### ADDENDUM 1

CSP 22-92

## Cavazos Elementary School Heating & Air Condition (HVAC) Improvements Funded through the Elementary & Secondary Emergency Relief (ESSER) Funds May 31, 2022

## Addendum

DATE:	05/05/2022
DRAWN BY:	DBR
CHECKED BY:	DBR
PROJECT NUMBER:	218007.005
SHEET TITLE:	LEVEL 1 MECHANICAL PLAN - DEMOLITION - AREA D
SHEET NUMBER:	MD2.14D

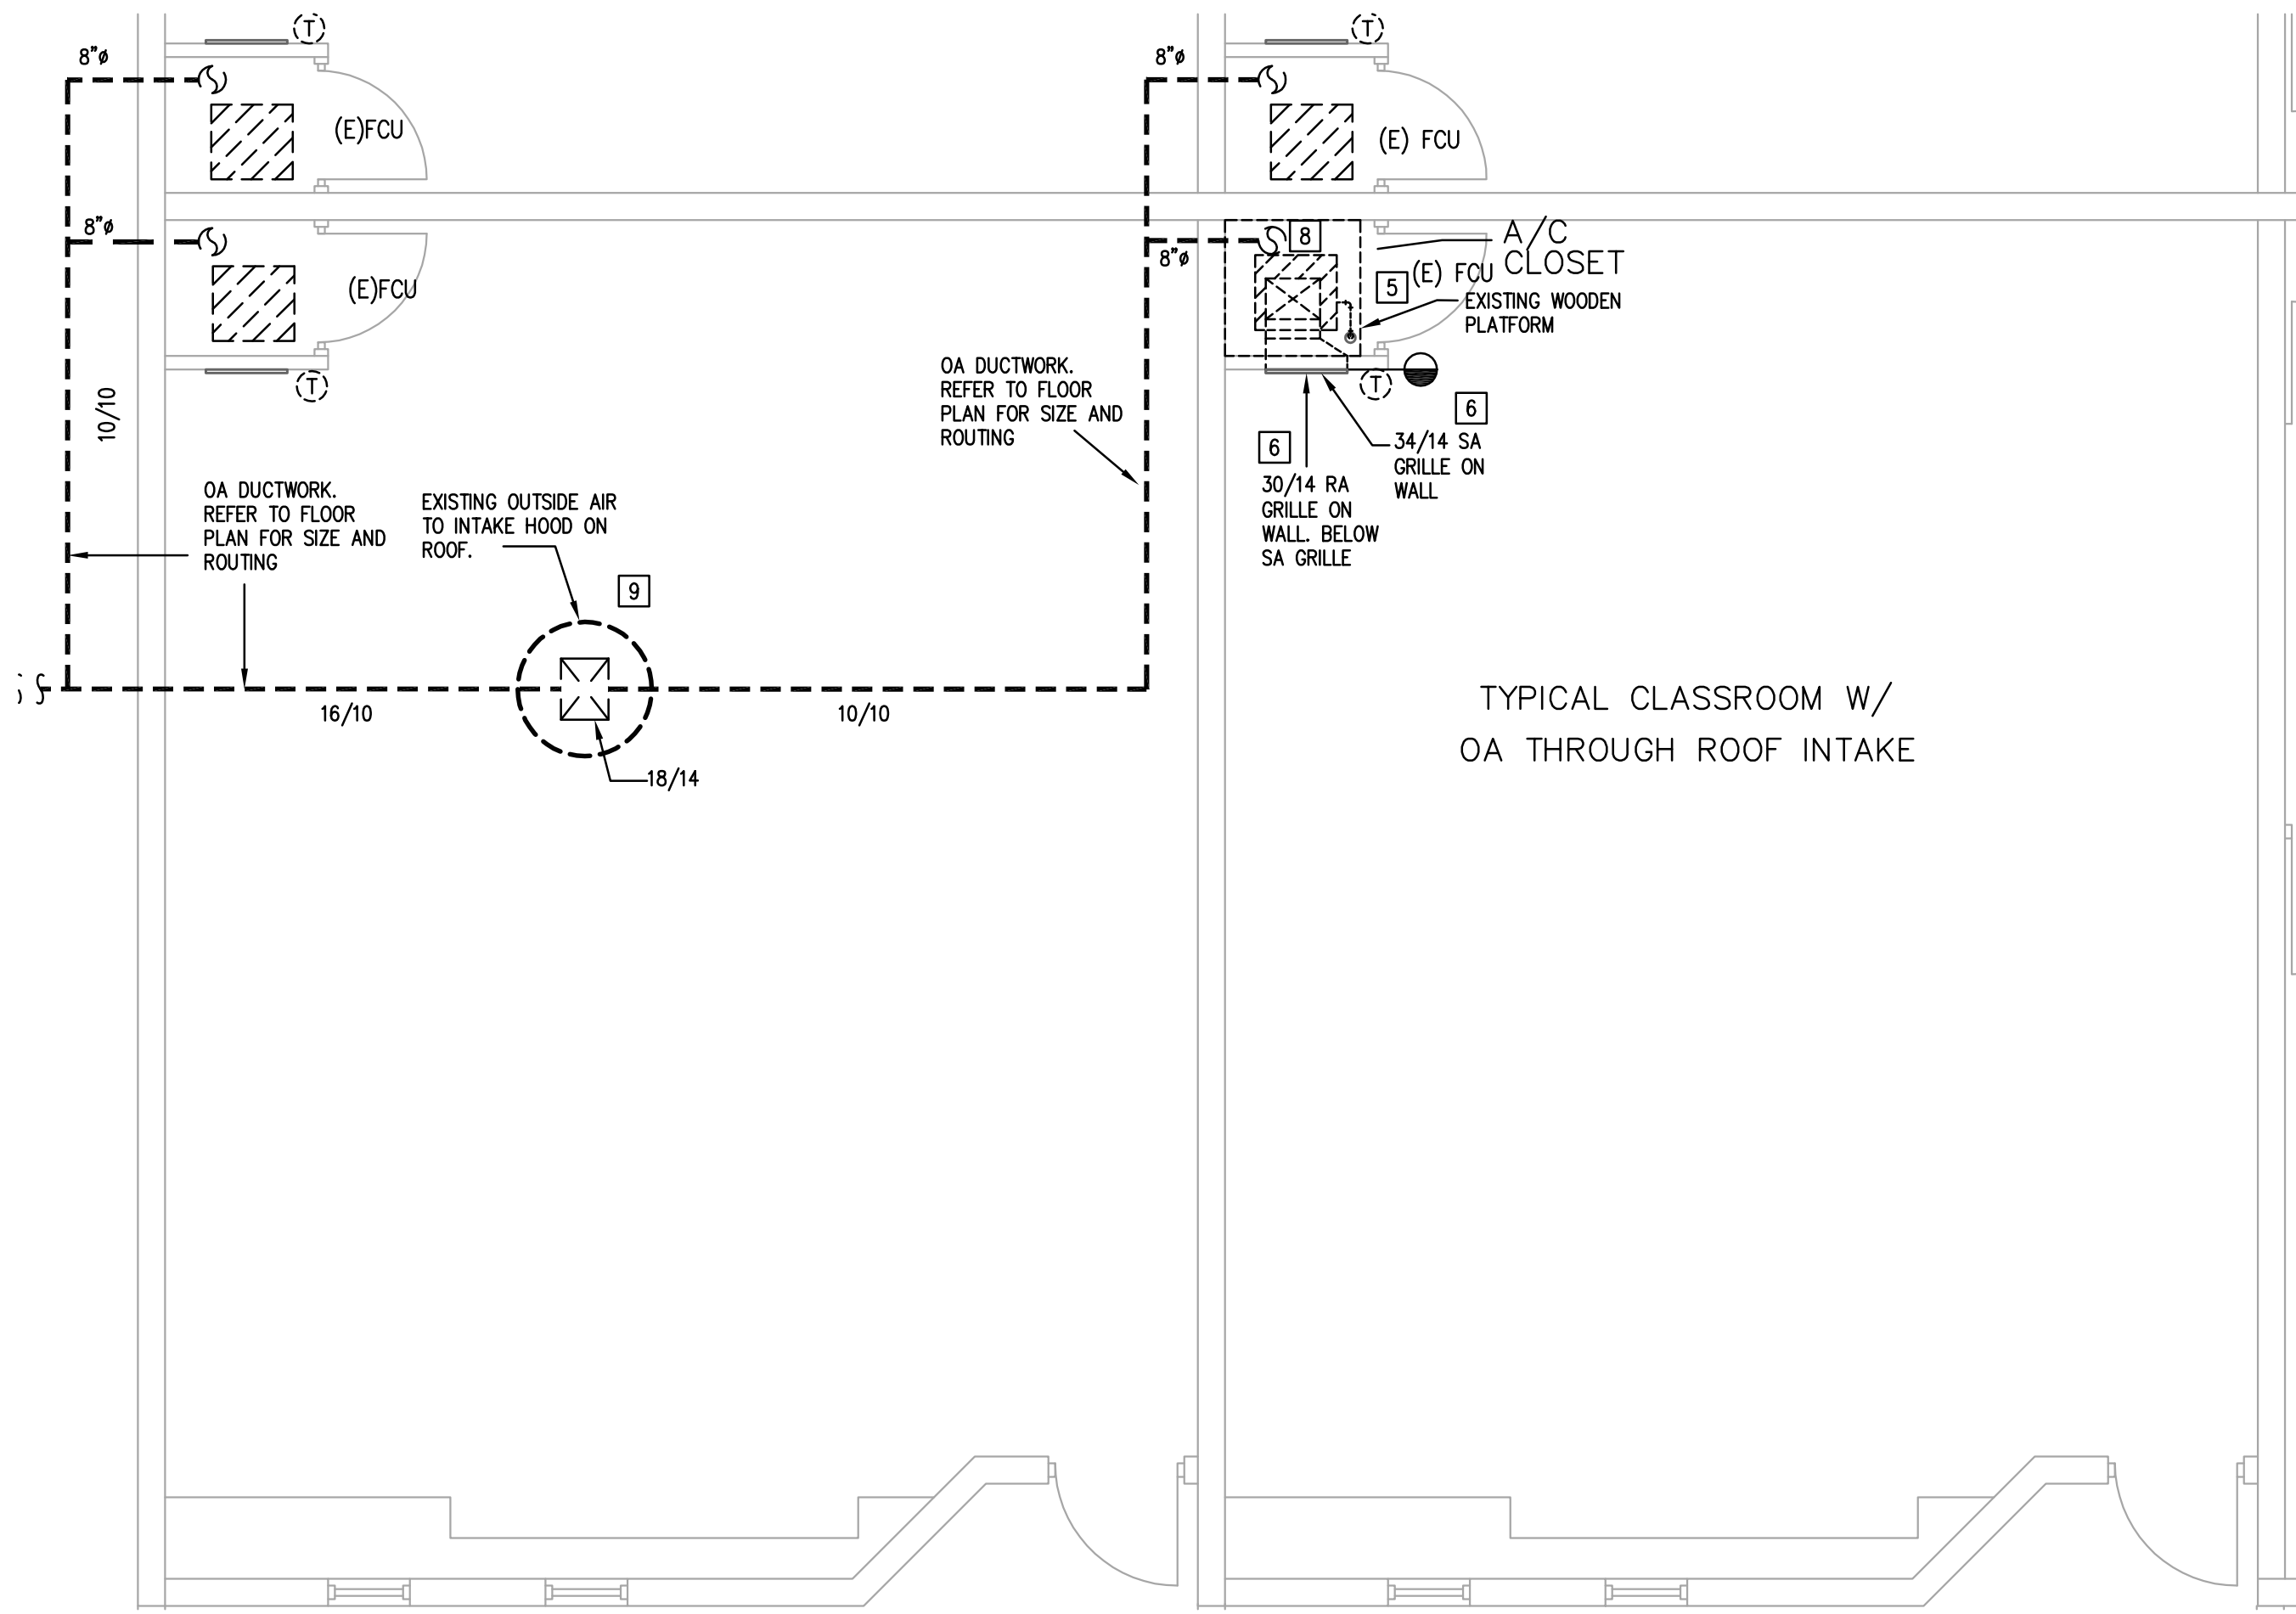
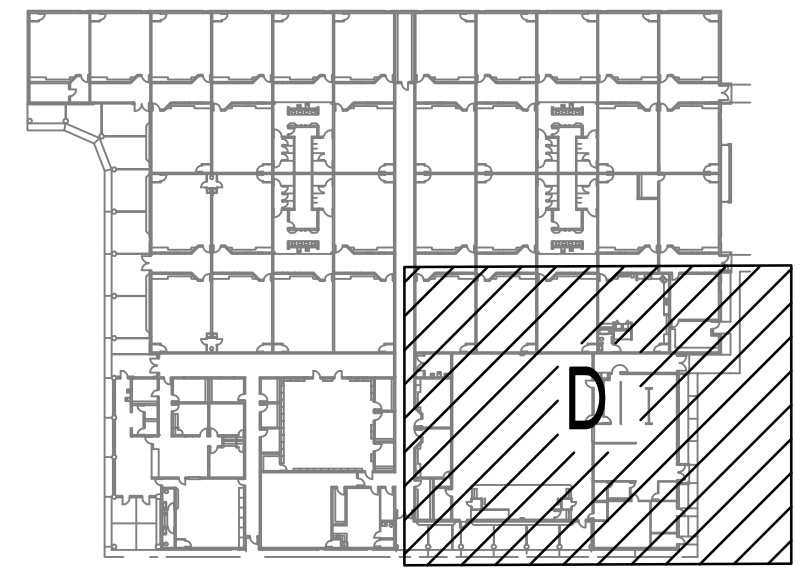
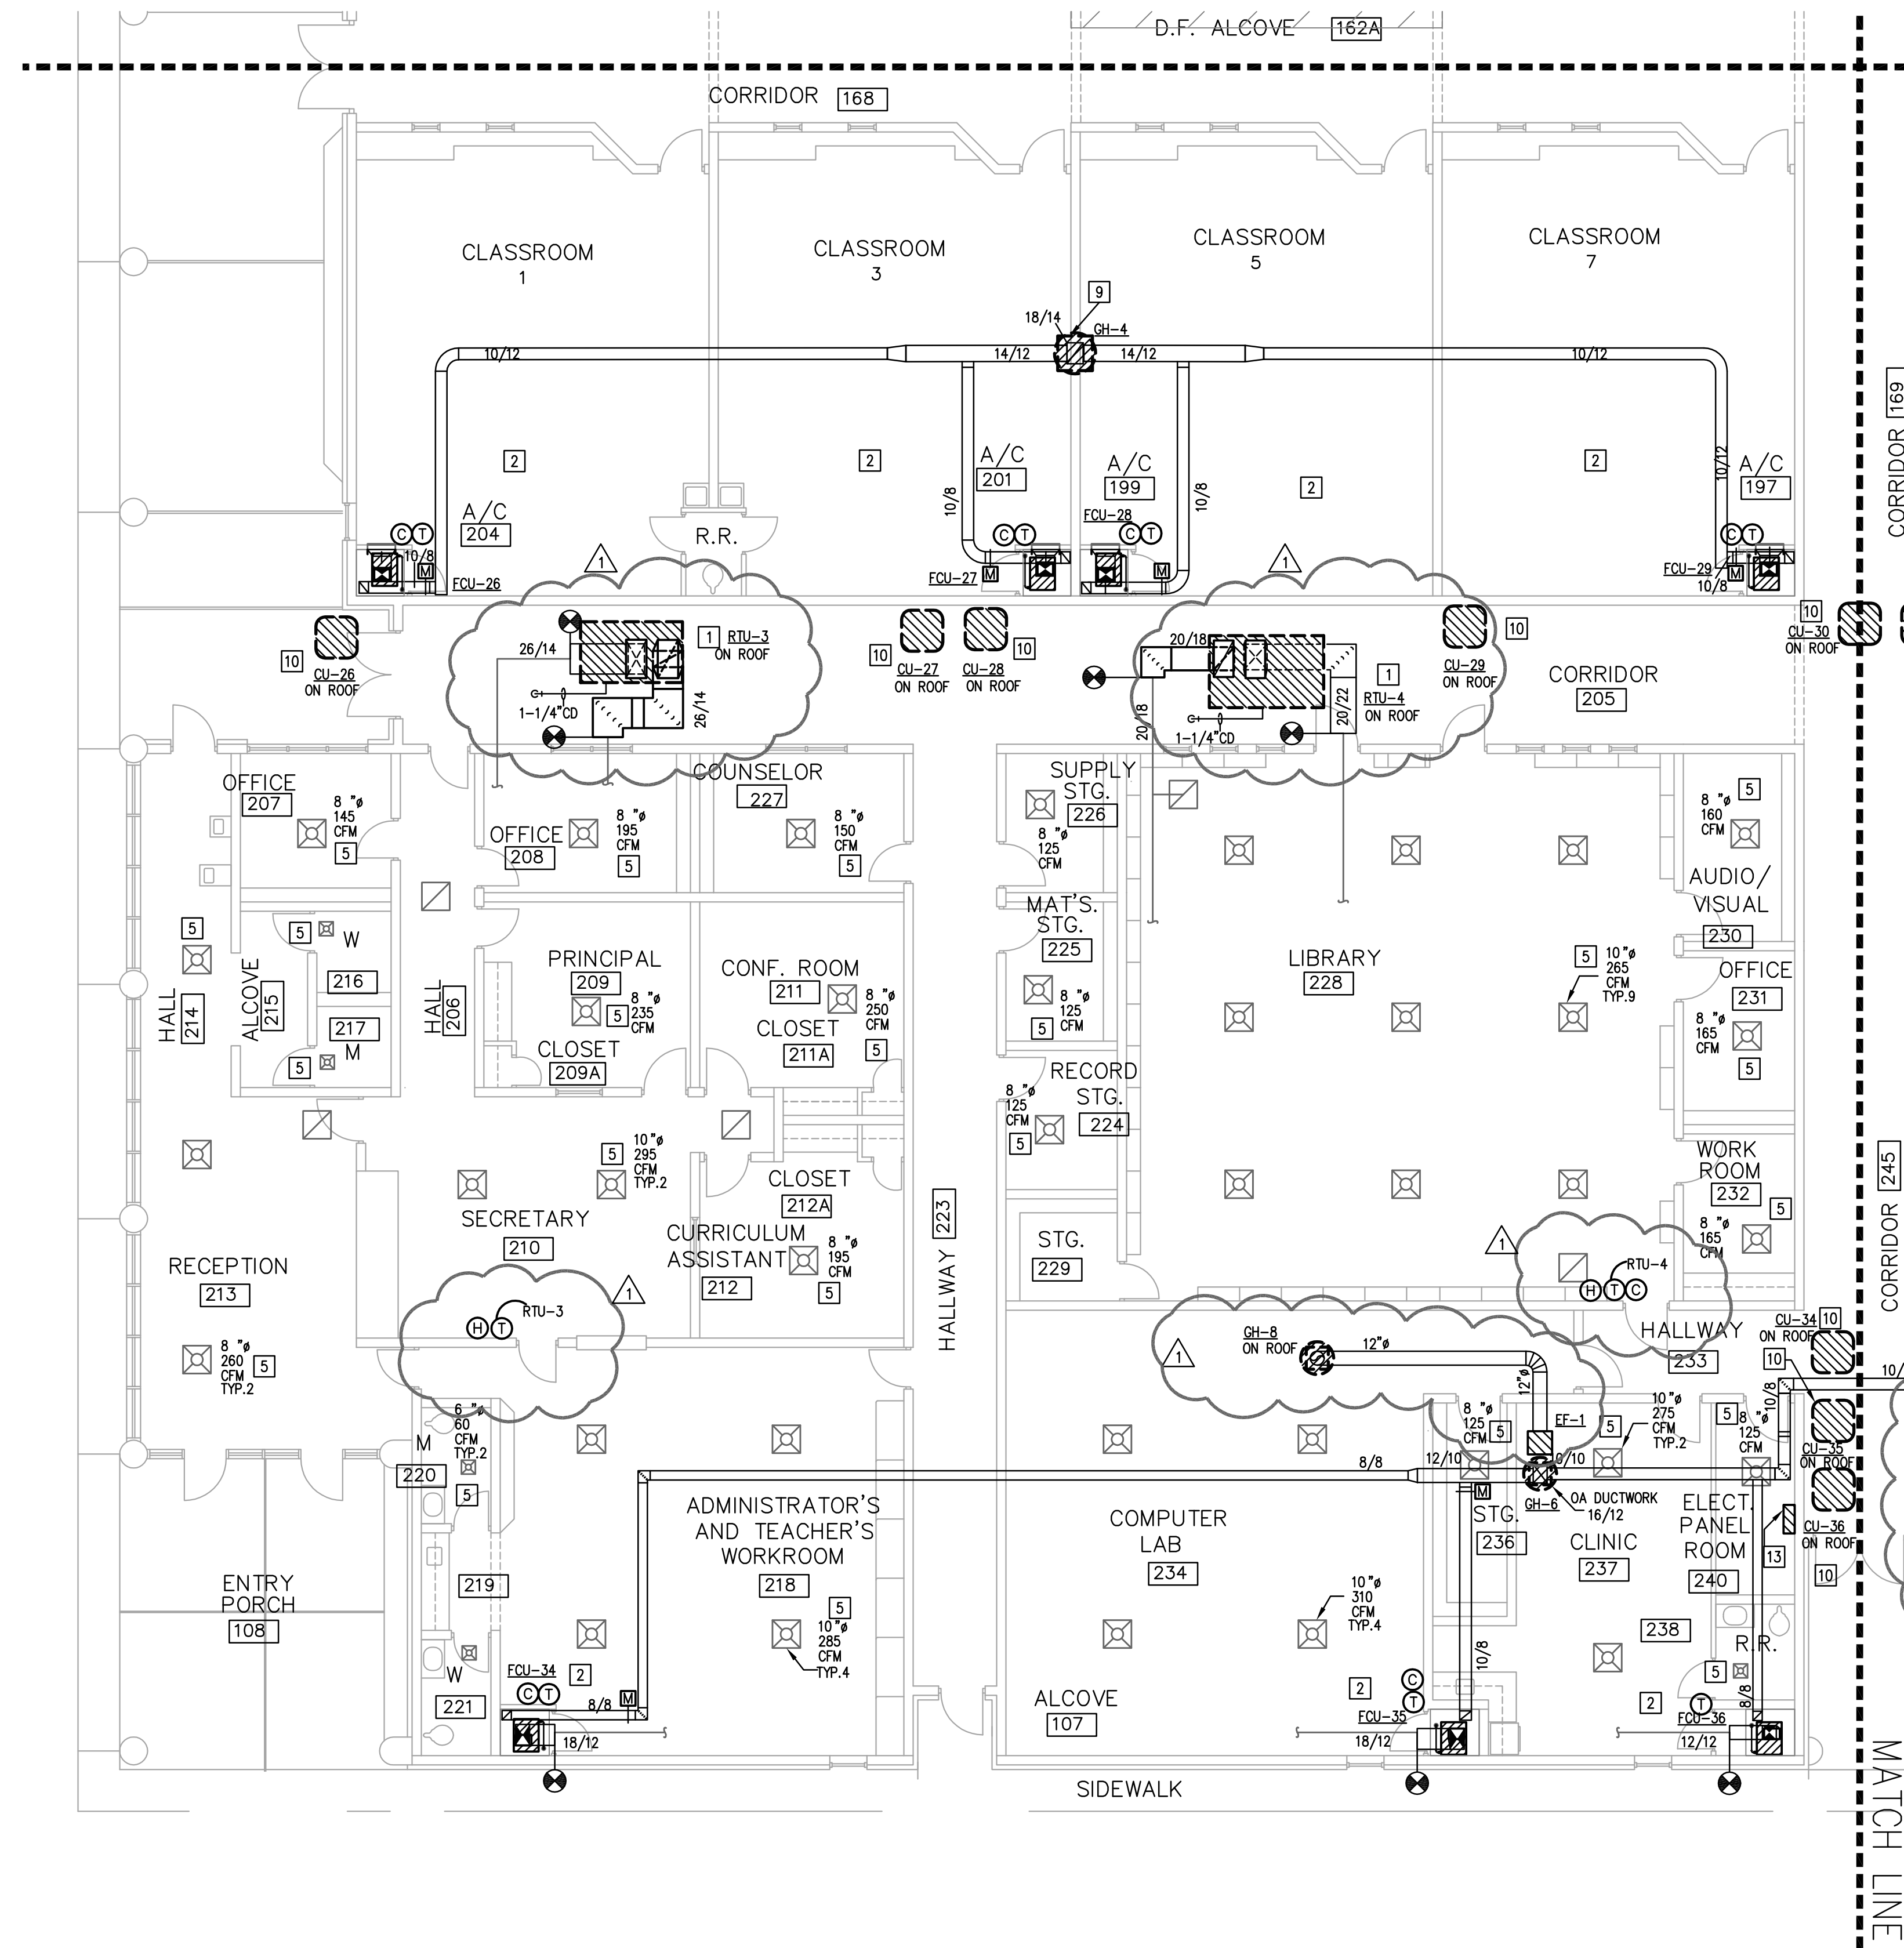
#### MD2.14D – Level 1 Mechanical Plan – Demolition – Area D

- A. Revised keyed notes 3, 5, 7, 10.
